Applicant: Ryan Dunlay: Knox and American 1, LLC  
Consultant: Dan Elenbaas; Kimley-Horn  
Project: The District  
Location: 8049 Morgan Circle; 1901 and 1951 American Boulevard West: Bloomington  
Rule(s): 4, 5, 11 and 12  
Reviewer: BCO

**Permit #:** 2019-68  
**Project Name:** The District; 8049 Morgan Circle, 1901 and 1951 American Boulevard West: Bloomington  
**Approval Date:** August 21, 2019

OVERALL GRADING PLAN

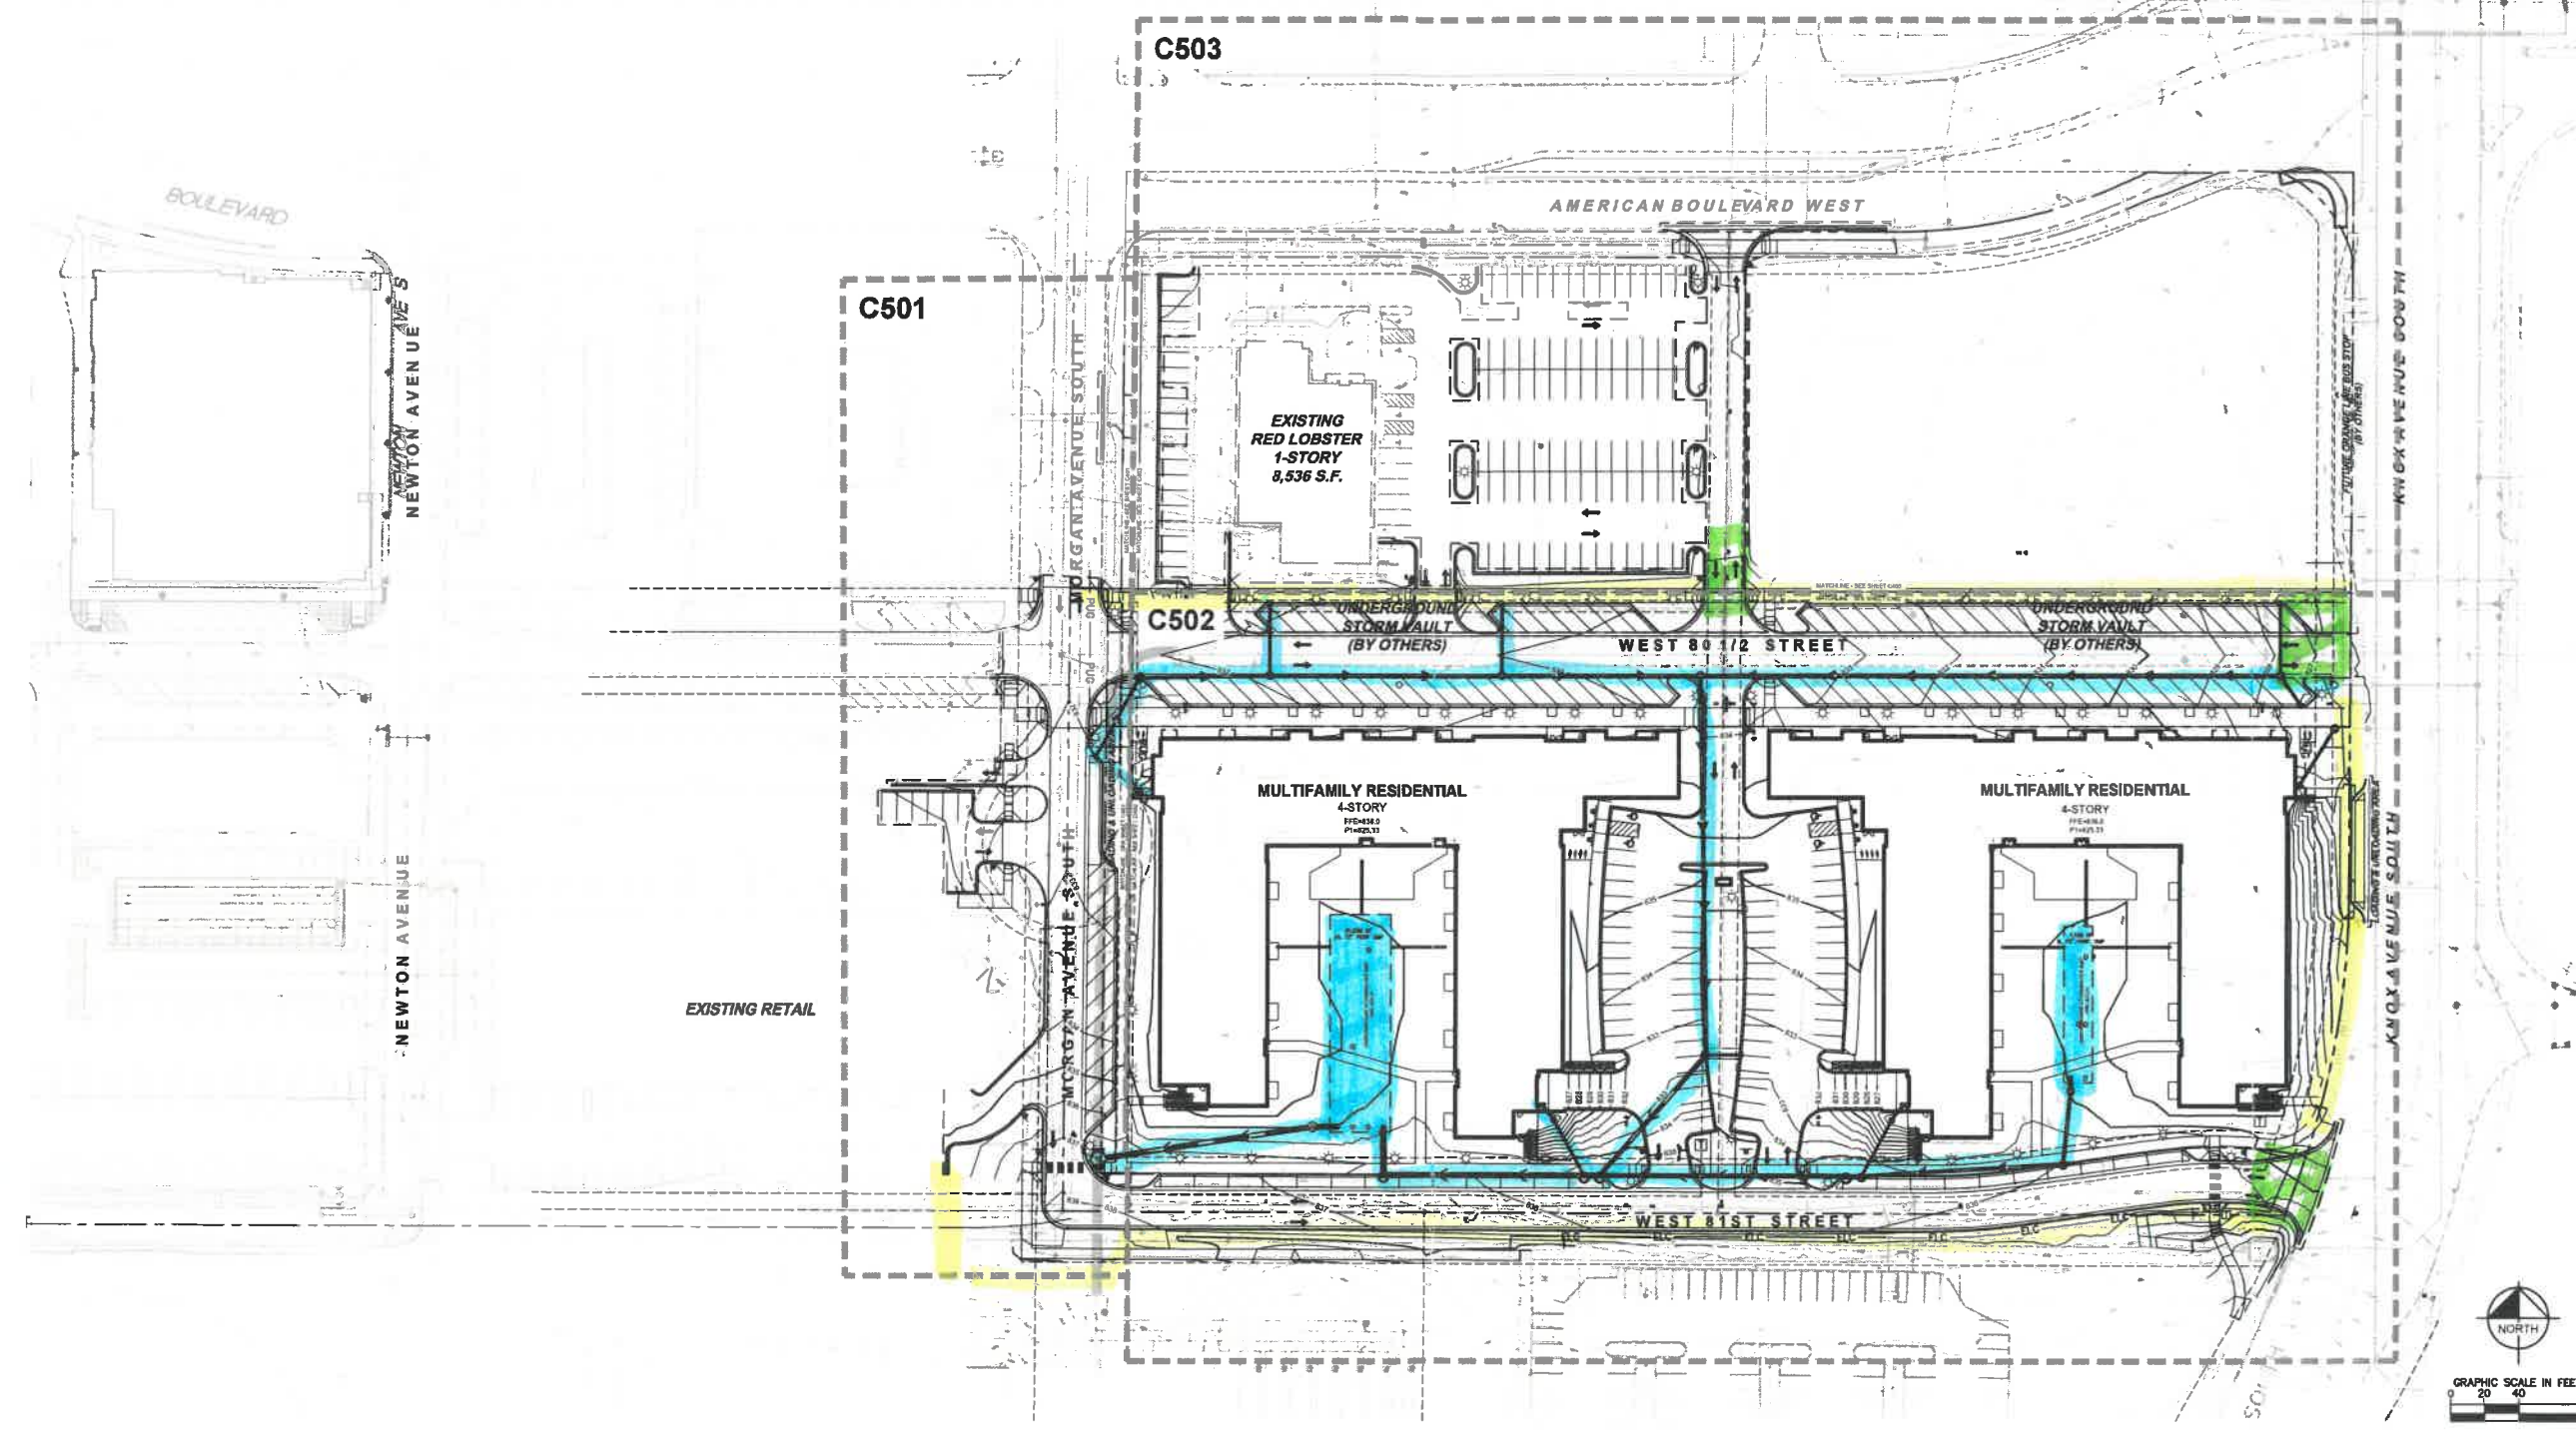
District Rule 4.3.3c states that all new and reconstructed buildings must be constructed such that the low floor elevation is at least two feet above the 100-year high water elevation or one foot above the emergency overflow of a constructed facility. The lower level parking for both buildings is to be 825.3 M.S.L. The calculated 100-year frequency high water elevation for both UGSWMF is 823.3 M.S.L. – providing two feet of separation complying with the rule.

District Rule 4.3.3 states that all new and reconstructed buildings must be constructed such that no opening where surface water can enter the structure is less than two feet above the 100-year high water elevation of an adjacent facility or waterbody. The low opening for the garage entryway of both building is shown to be 825.7 M.S.L. – a separation of 2.4 feet above the high water elevation of the UGSWMF. This requirement of paragraph 4.3.3 is met.

The geotechnical report indicates that groundwater was encountered approximately at elevation 810 M.S.L. The bottom elevation of both the UGSWMF is to be 817.5 M.S.L, a separation of 7.5 feet. A minimum separation of 3 feet is required between the bottom of an infiltration facility and groundwater.
